VA HELENA, MONTANA 59601

MAY 13 1974

This draft environmental impact statement is submitted pursuant to the Montana Environmental Policy Act, (MEPA) Section 69-6504 (b)(3). The statement was prepared by the Environmental Sciences Division of the Montana State Department of Health and Environmental Sciences, regarding a proposed hydrometallurgical operation using the Arbiter reduction process, which would be built near Anaconda. The Anaconda Company has applied to the Air Quality Bureau for a permit to build the portion of the plant that might be capable of emitting air contaminants.

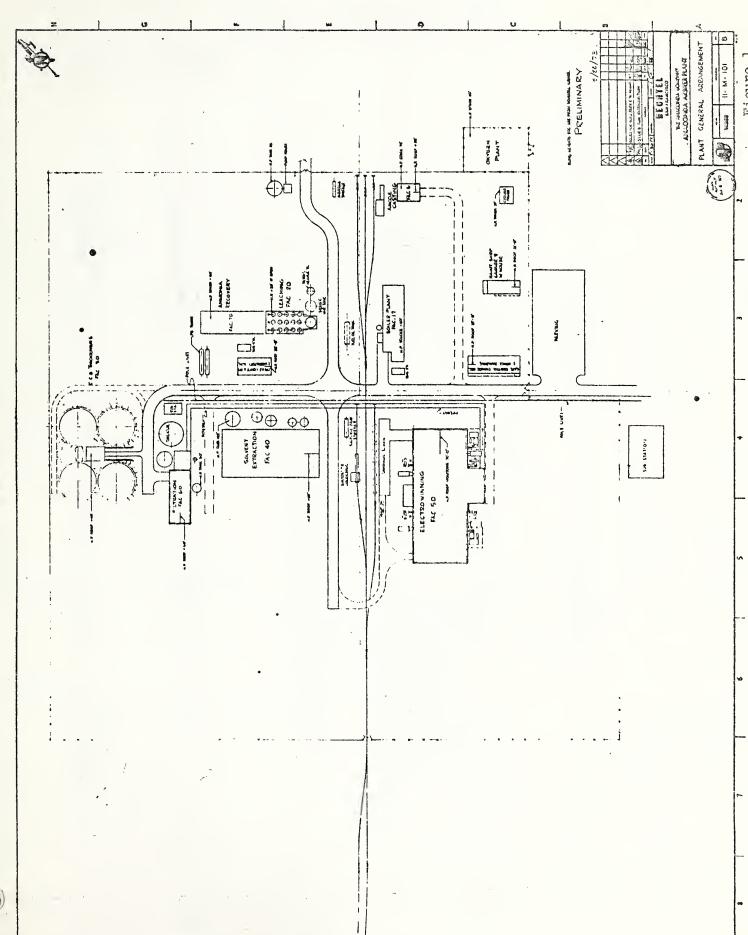
The spent electrolite is bled from the system to where? Reference figure 2.

Schematic Diagram

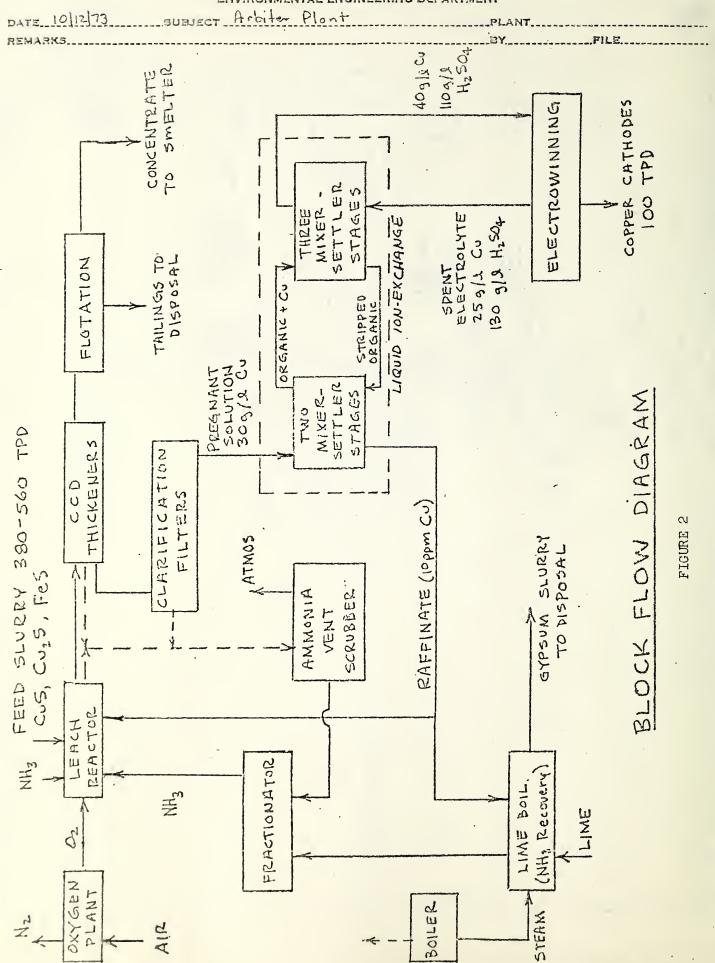
The legend on Figure 4 and most of the printing on the figure is illegible.
